Access Compliance Report Public Rights-of-Way (Curb Ramps)

Main Street: SYLVANOAK_WAY Cross Street: MARSTON_LN Location: S

ADA ID: RPRK211115121421 Ramp Type: Type 4 - Parallel Initial Pass/Fail: Fail Overall Compliance: No Severity Score: 2

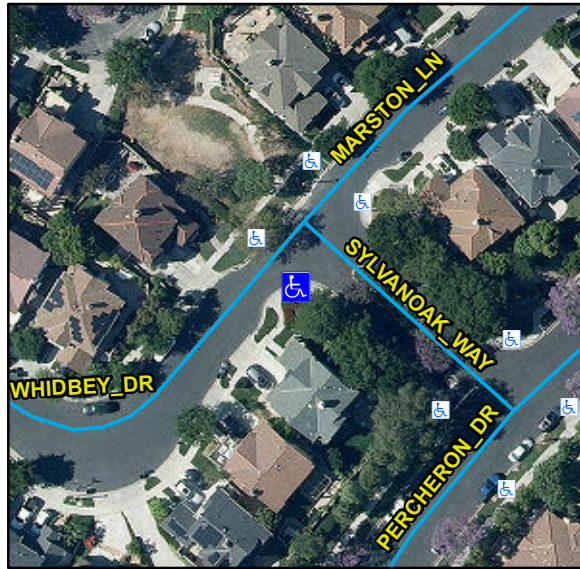
Compliance	Description	Data	Compliance	Description	Data
N/A	Ramp Length LT (in)	141	N/A	Ramp Length RT (in)	138
Yes	Ramp Width LT (in)	52	Yes	Ramp Width RT (in)	50
Yes	Ramp Run Slope LT (%)	2.4	Yes	Ramp Run Slope RT (%)	5.9
Yes	Ramp Cross Slope LT (%)	1.8	No	Ramp Cross Slope RT (%)	3.7
N/A	Landing Present	N/A	N/A	DWS Provided	N/A
N/A	Landing Length (in)	N/A	N/A	DWS Contrast	N/A
N/A	Landing Width (in)	N/A	N/A	DWS Length (in)	N/A
N/A	Landing Run Slope (%)	N/A	N/A	DWS Full Width	N/A
N/A	Landing Cross Slope (%)	N/A		DWS Offset Type	N/A
N/A	Landing Movement Obstructed?	N/A	N/A	DWS Offset Left (in)	N/A
	Landing Movement Type	N/A	N/A	DWS Offset Right (in)	N/A
N/A	Landing Shared	N/A			
N/A	Clear Space	Yes			
N/A	Clear Space To Crosswalk (in)	N/A			
N/A	Marked Crosswalk 1	No	N/A	Marked Crosswalk 2	No
	Crossing 1 Direction	NE		Crossing 2 Direction	NW
	Marked Crosswalk 1 Width (in)	N/A		Marked Crosswalk 2 Width (in)	N/A

Remove & Replace Curb Ramp With Two New Directional Ramps or Equivalent.

R204.3, R304.5.3, STD 1115
